Village of Winnetka

Design Review Board/Sign Board of Appeals Regular Meeting

a. **Case No. 24-14-SU: Grace Presbyterian Church of the North Shore (440 Ridge Avenue): A Certificate of Appropriateness to allow construction of additions and site improvements to Grace Presbyterian Church of the North Shore. The Village Council has final jurisdiction on this request. This item was continued from the June 20, 2024, and July 18, 2024 Design Review Board meetings. The Applicant is requesting this item be continued to the September 19, 2024 Design Review Board meeting.**

Attachment A1: Applicant’s Explanation of Revised Design and Revised Plans

SOUTHEAST AERIAL

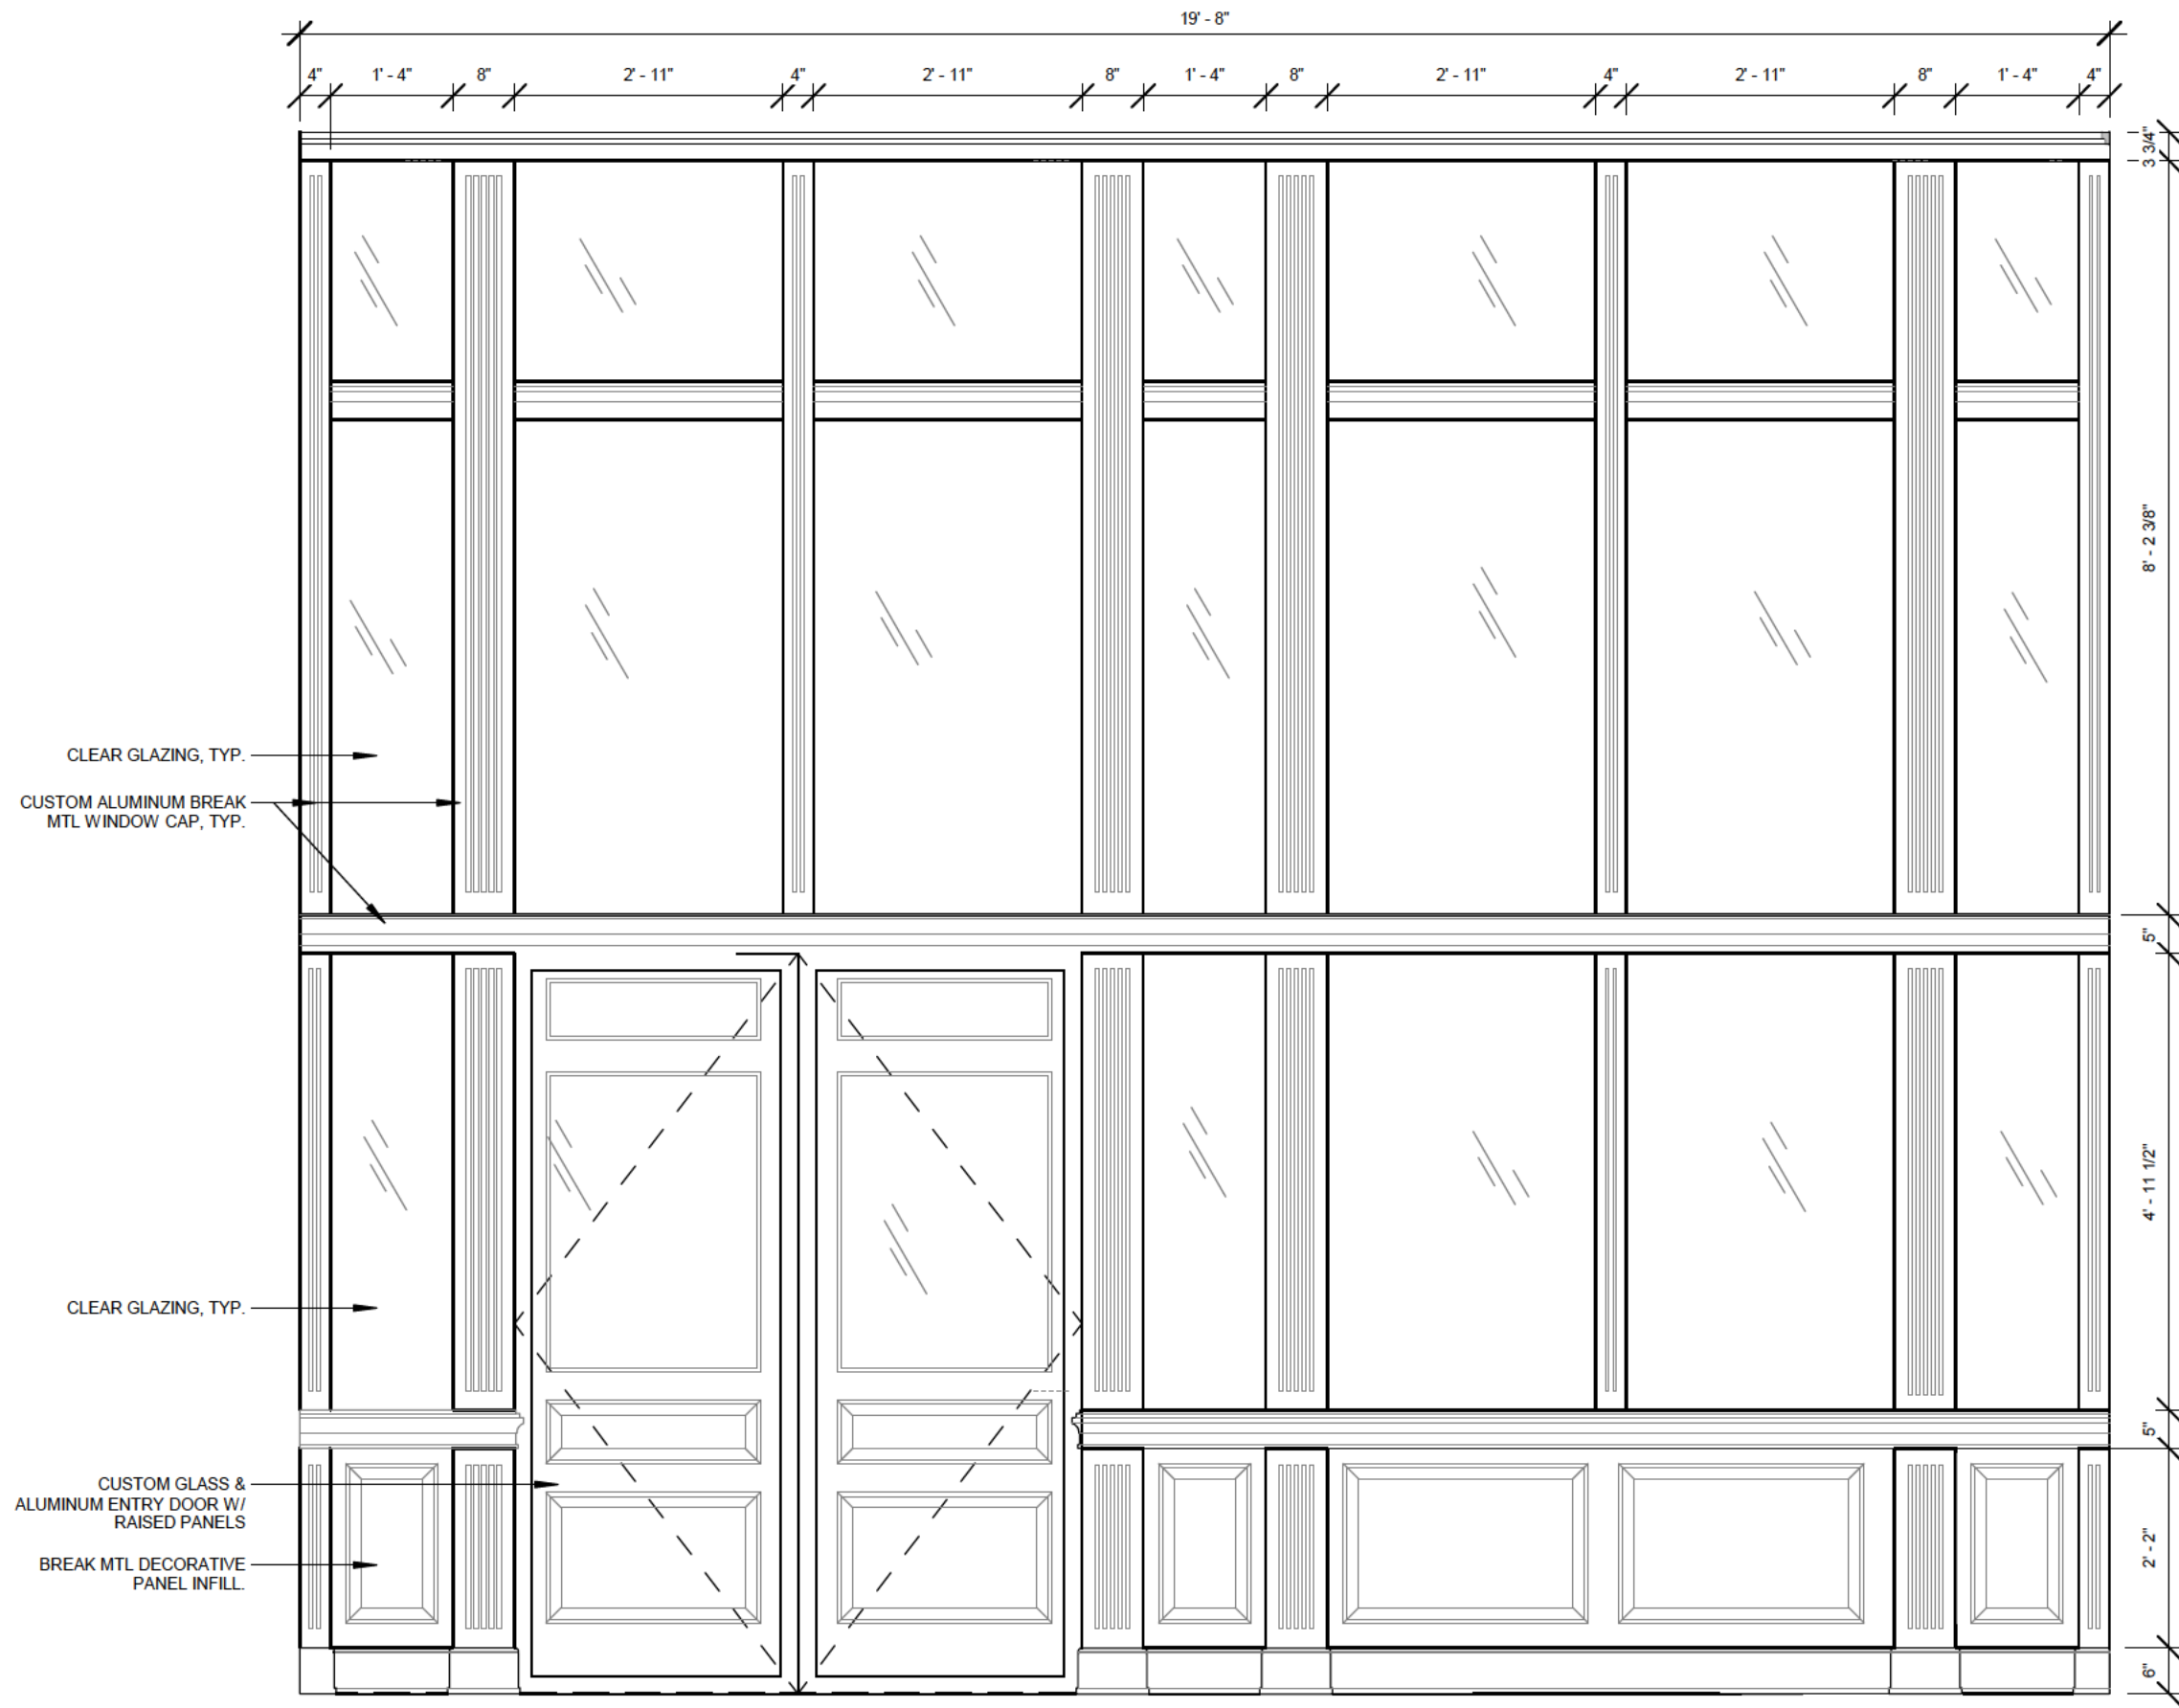
1. Landscape buffer on east side of the south addition to soften the appearance / more residential feel.
 2. Landscape buffer & modification of entry link (reduction in glass)

3. Landscape buffer & alternate modification of the entry link (residential scale windows)
 - e. Providing a pedestrian view of the rooftop mechanical equipment and screening.
Mechanical equipment will be housed under the gable roof of the south addition in the attic space (see SP-013). There will be no view of the mechanical equipment.

SP-034

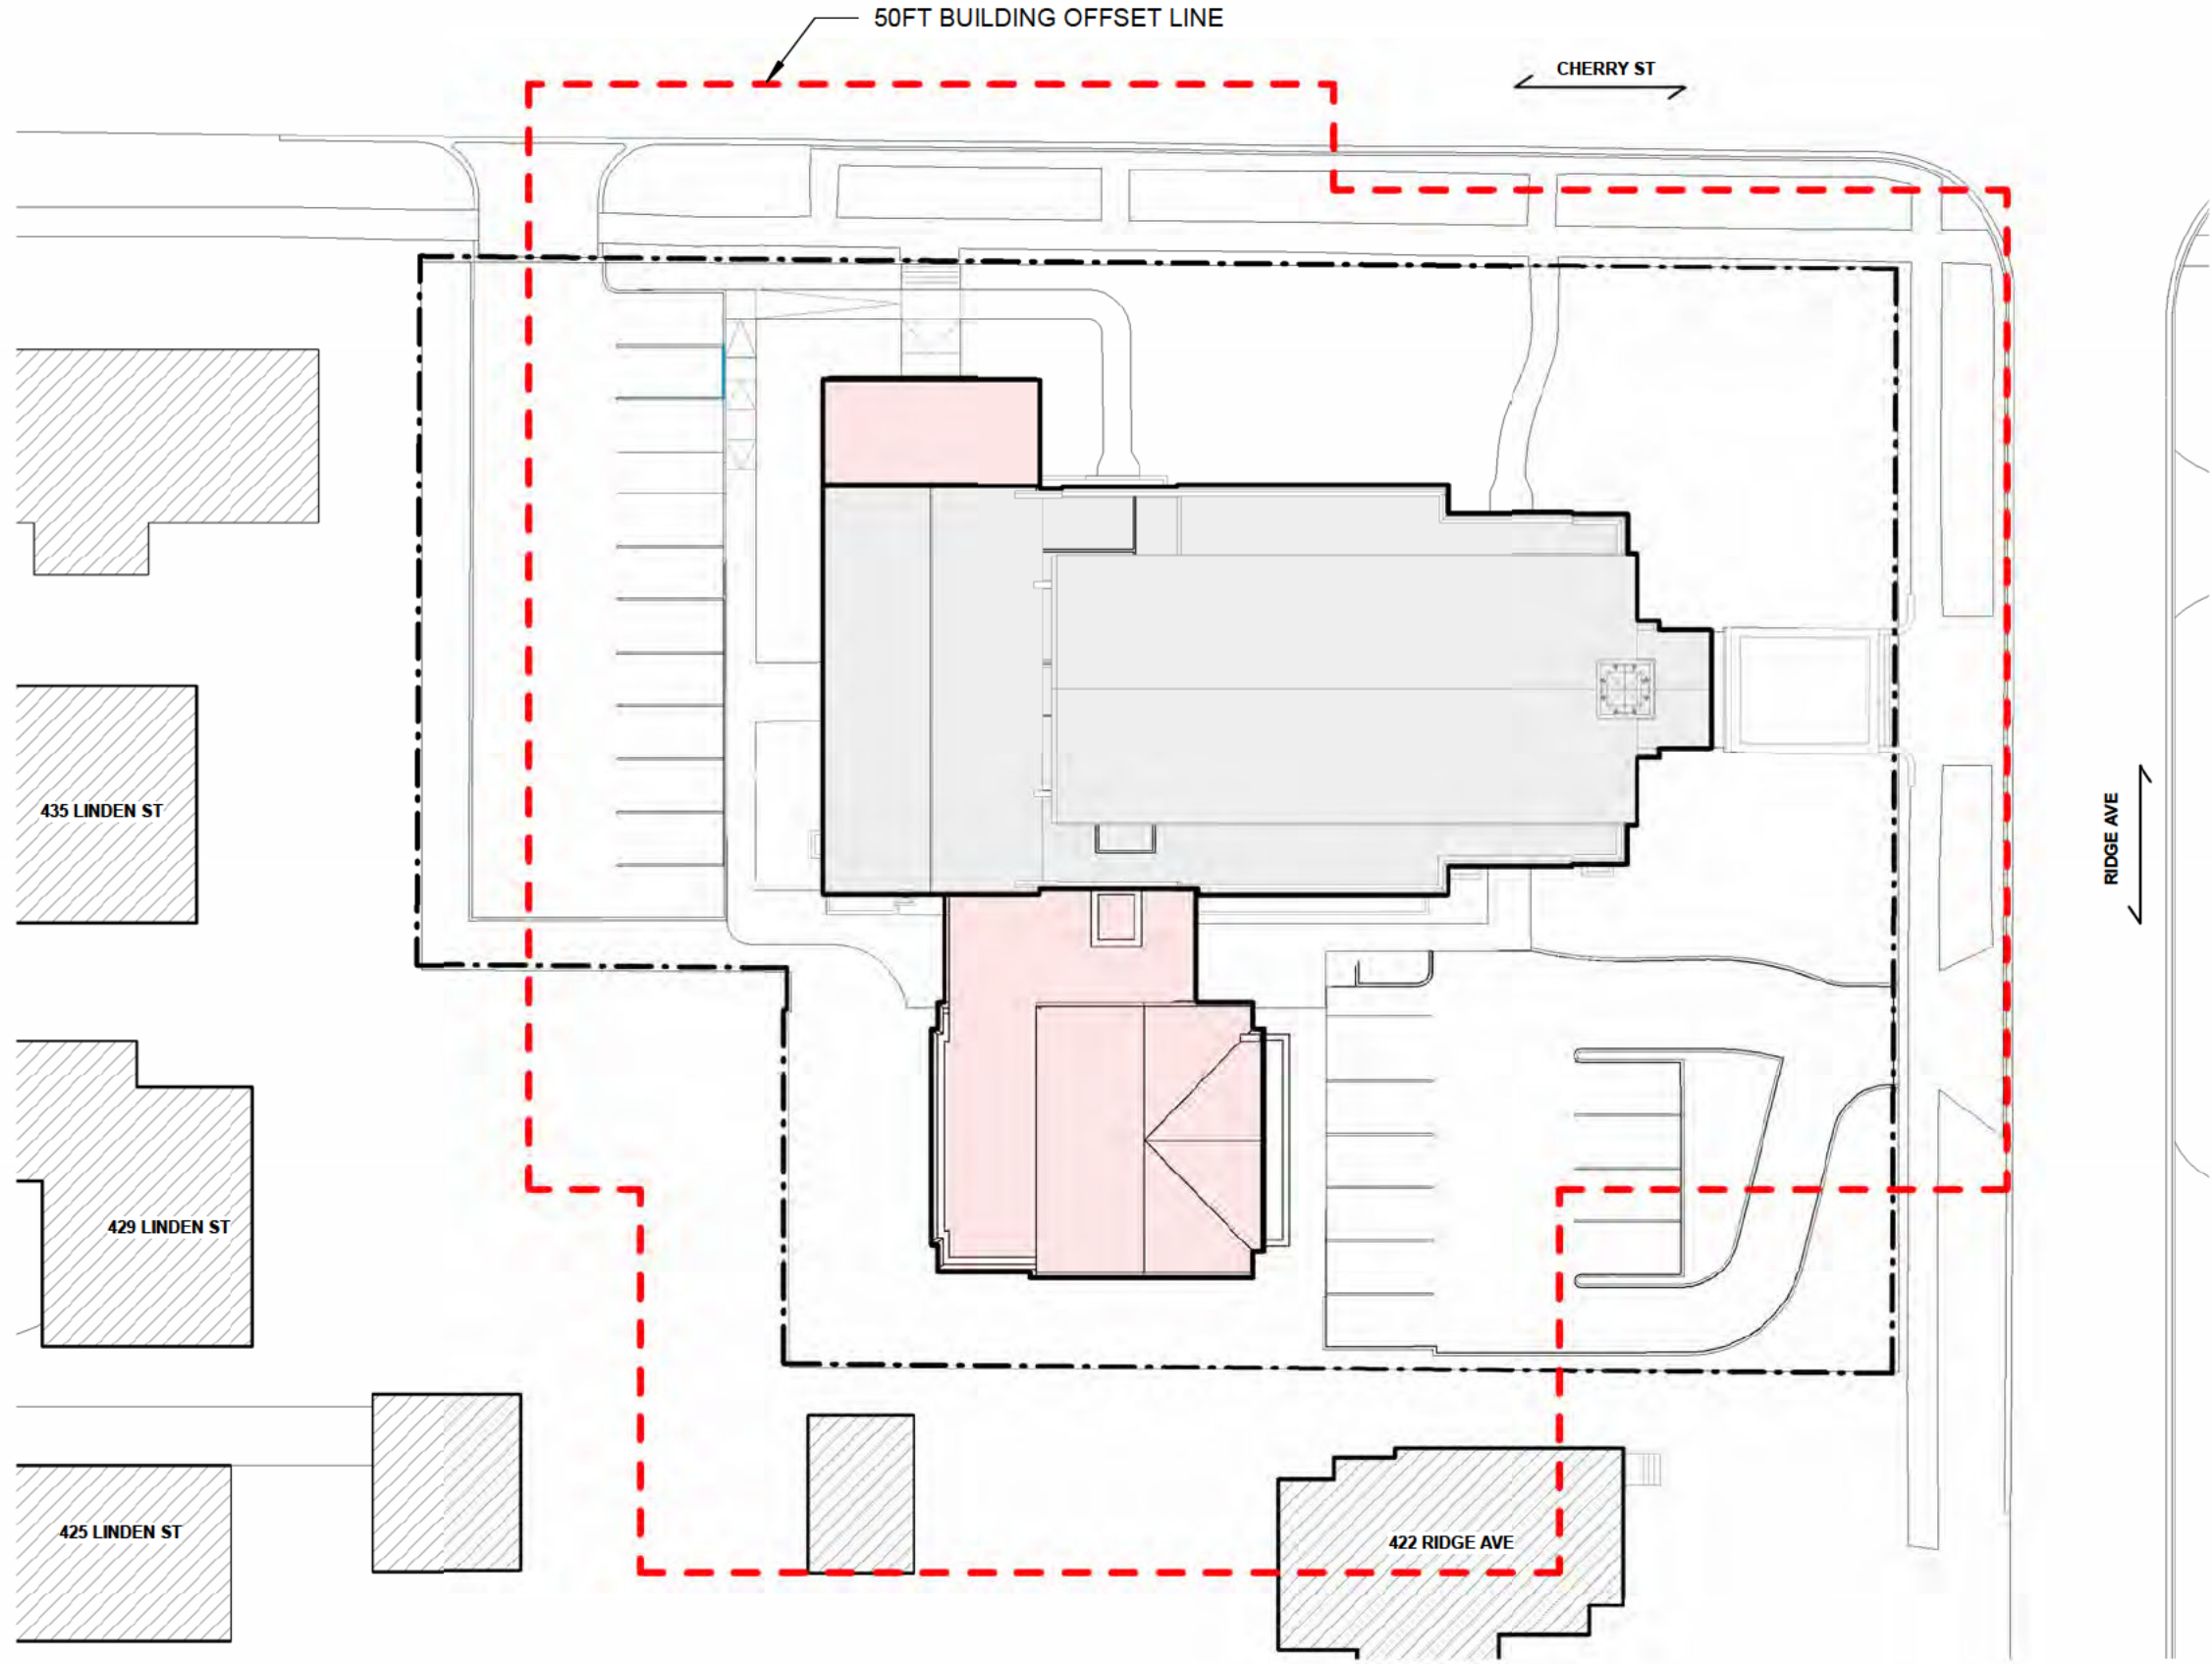
- f. Bollard light fixtures that are more neighbor friendly (not so tall).
Bollard light fixture has been revised to an 18" tall path light – see SP-033.
